DEPARTMENT OF PLANNING AND COMMUNITY DEVELOPMENT

CASE NO.: 07-SPR-008

LOCATION: 5575 Micaela Drive
(A.P.N. 2053-024-097)

REQUEST: Request for approval of a Site Plan/
Architectural Review application to construct a
first and second-story addition and a garage
addition, totaling 1,672 square feet, to an
existing two-story residence.

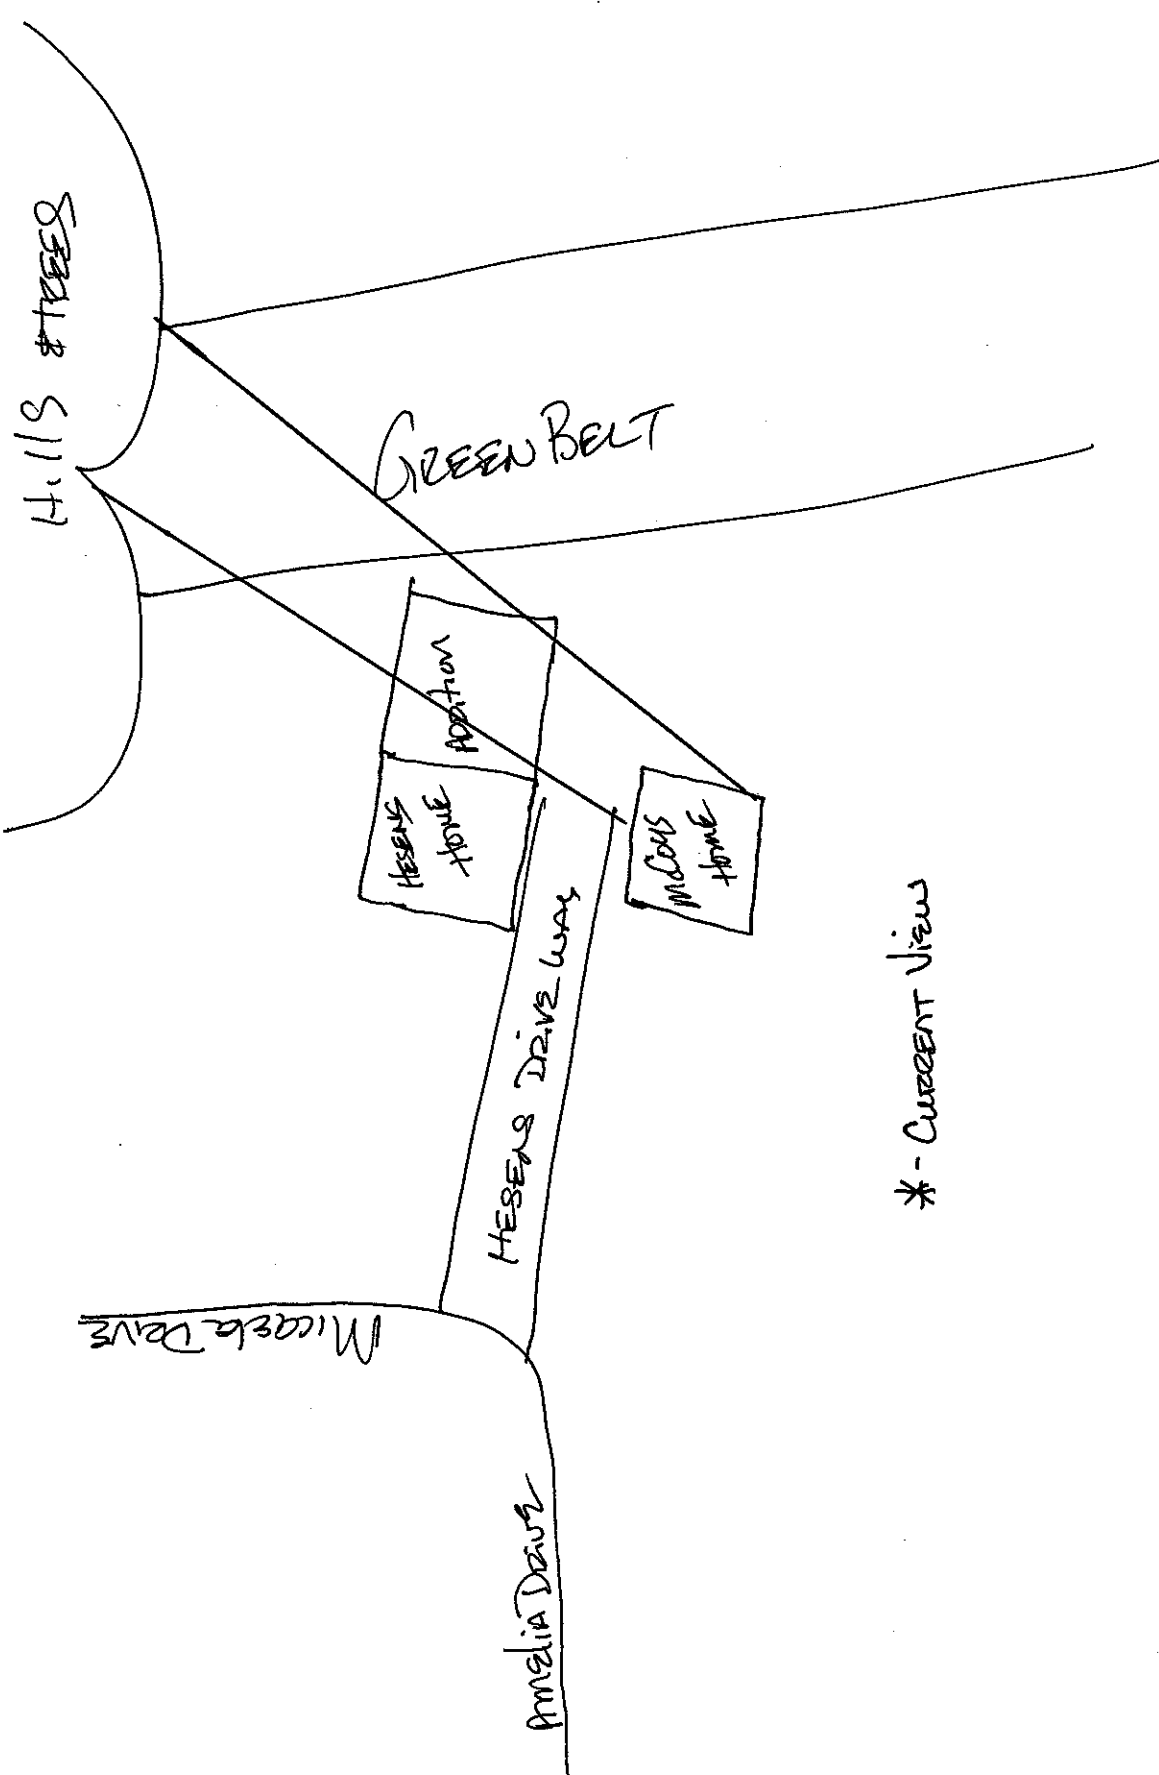
Enclosed are pictures and a diagram to demonstrate the view we would be losing in addition to pictures showing the angle the Hesens' would have looking into our home.

* - CURRENT VIEW

* View from our bedroom. This also demonstrates the angle the would have looking into our bed room.

* View from our patio —

* The View angle the Hezen's would have looking into our family room & dining AREA.

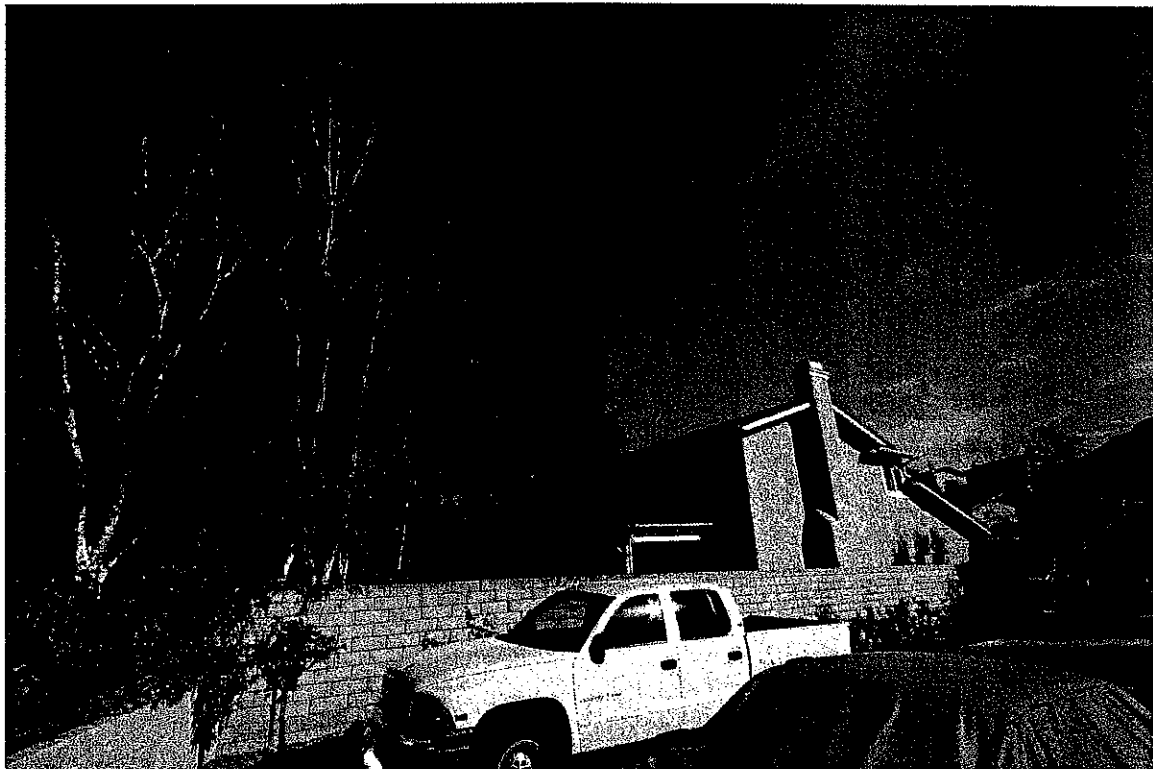
View through the Hesen Property: The Hesen family has been holding this portion of their lot for a future addition since they purchased the property. There are no trees and minimal landscaping in this flat area of their property. While the adjacent neighbor may have become accustomed to the openness afforded by this lack of trees, foliage or building, I know of no place in the jurisdictional codes that grant a protection of open space to neighbors. The concern has been raised by the McCoy's that they can see the mountains from their property, and this view would be restricted with the addition. In fact, the McCoys have four large trees on their property, which range in height from 20'-0" to 30'-0;" one of which is a California Redwood. Their current view from their ground floor of mountains or rather open space as seen in the picture below is severely restricted by the trees on their own property, the 6'-0" block wall on the property line, and their own patio cover. See picture below.

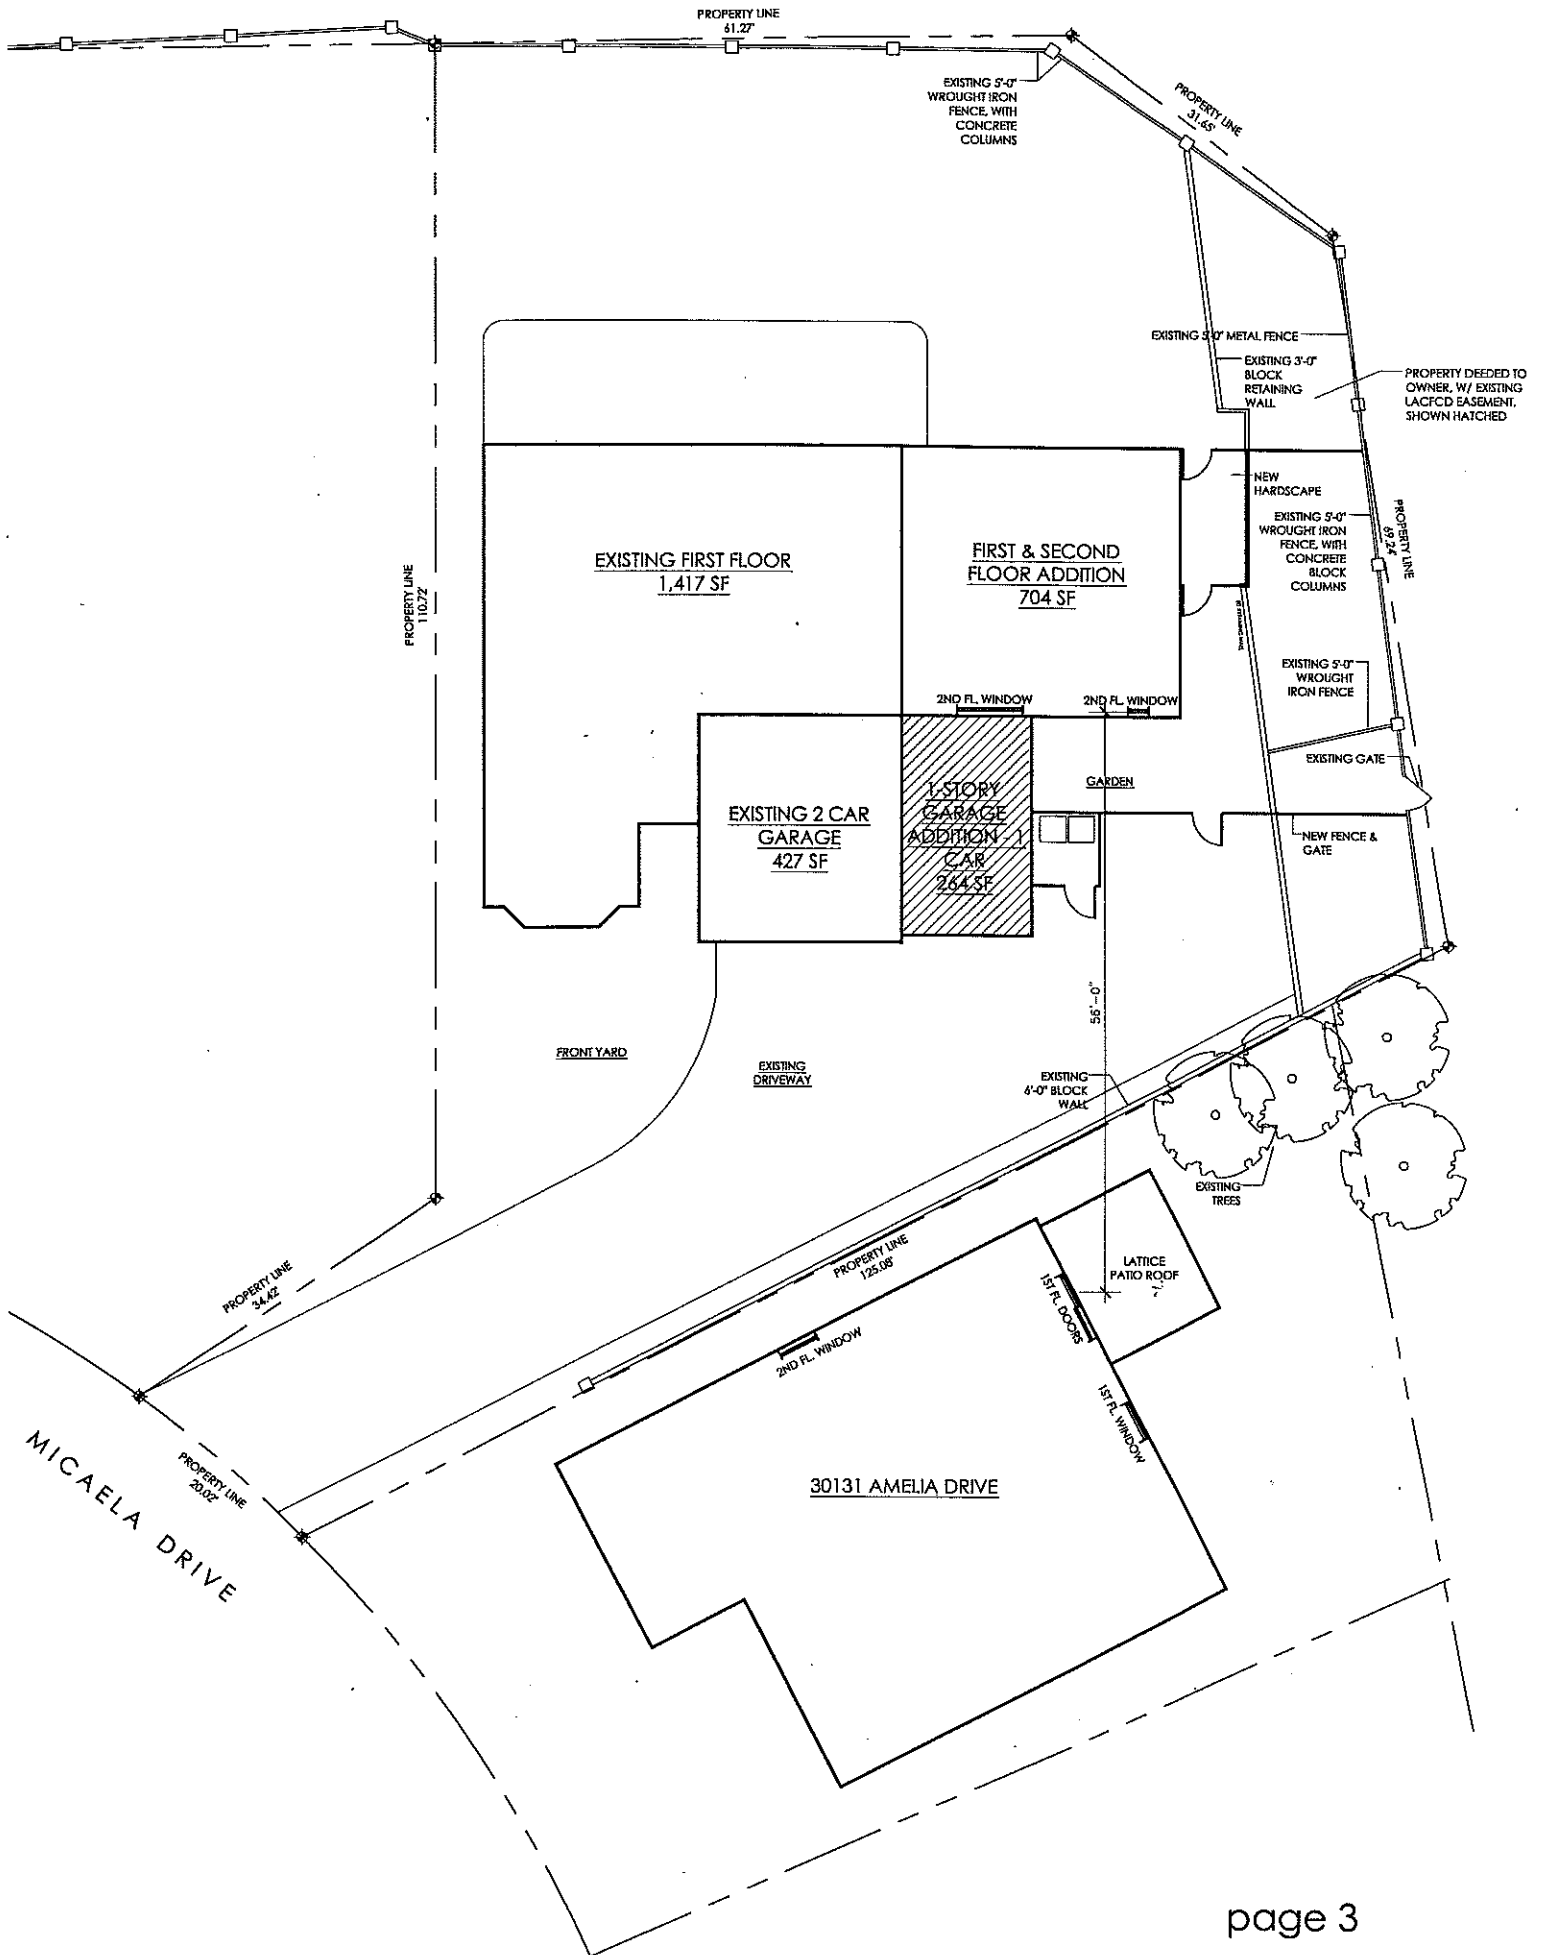
Again, in an attempt to minimize impact to the McCoy's, the proposed two-story addition was aligned with the current two-story portion of the Hesen home. I want to also point out, that this view area of concern is as an extreme oblique angle. See diagram below.

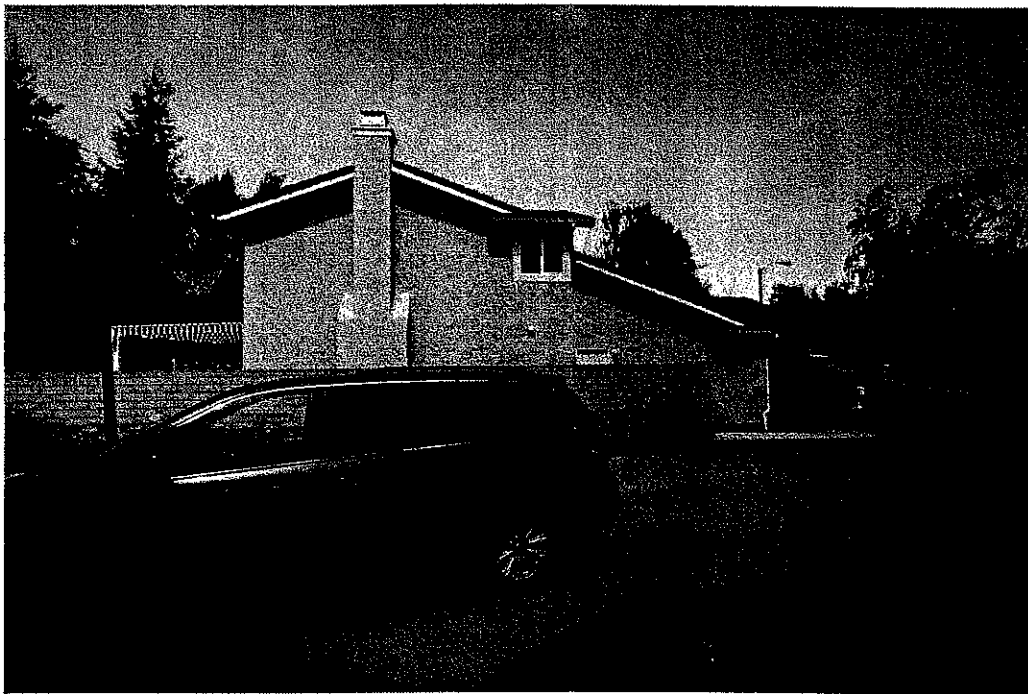
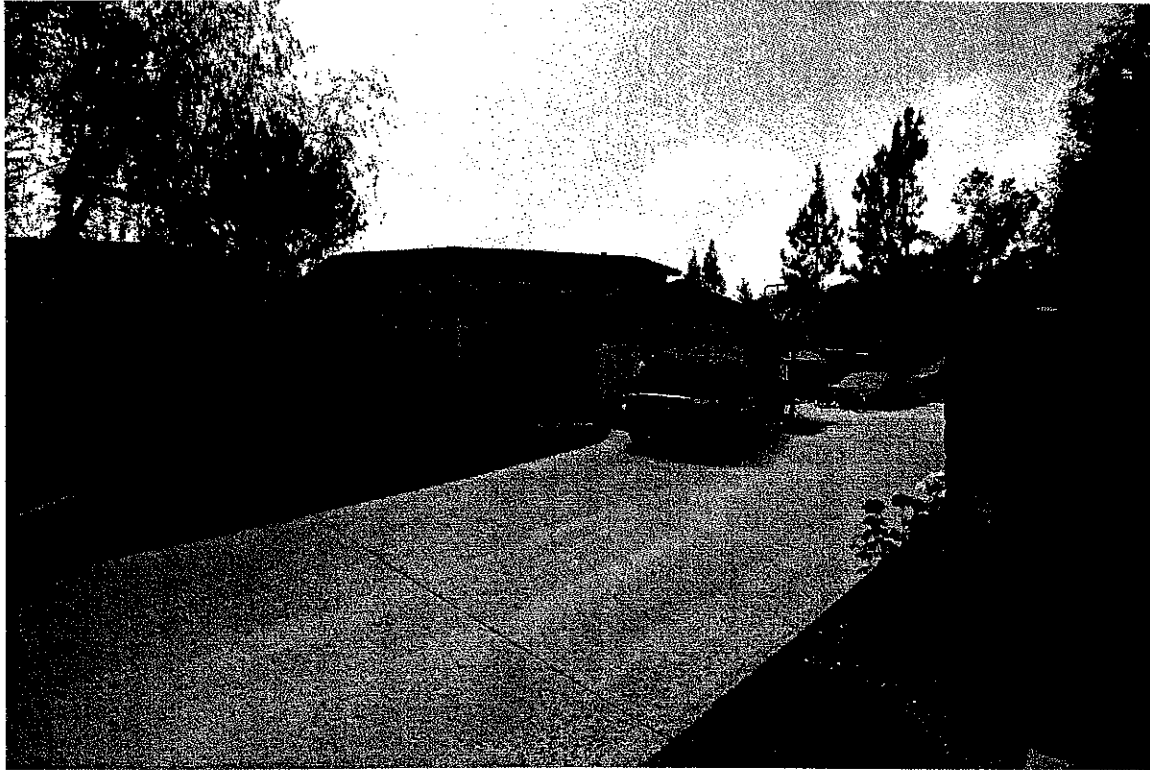
View into McCoy Property: As stated above, the Hesens' proposed two-story addition is aligned with the existing building mass. There are existing windows that look onto the side of the McCoy's property, *as would be expected with a home located on a flag lot*. In fact, the McCoy's have a second-floor side window looking at the Hesens home, which is much more invasive, as it is approximately 6'-0" from the shared property line. See photo below.

The Hesens' existing and proposed second-story windows are all located over 30'-0" from the shared property line. Also, because of the siting of the two homes, there is a severe angle looking from the Hesens' home into the windows facing the backyard of the McCoy residence. We calculate that from the Hesens' closest window in the proposed master bathroom to the McCoy's windows is over 50'-0." It will be almost impossible to view into the McCoy's home because of the angle and distance.
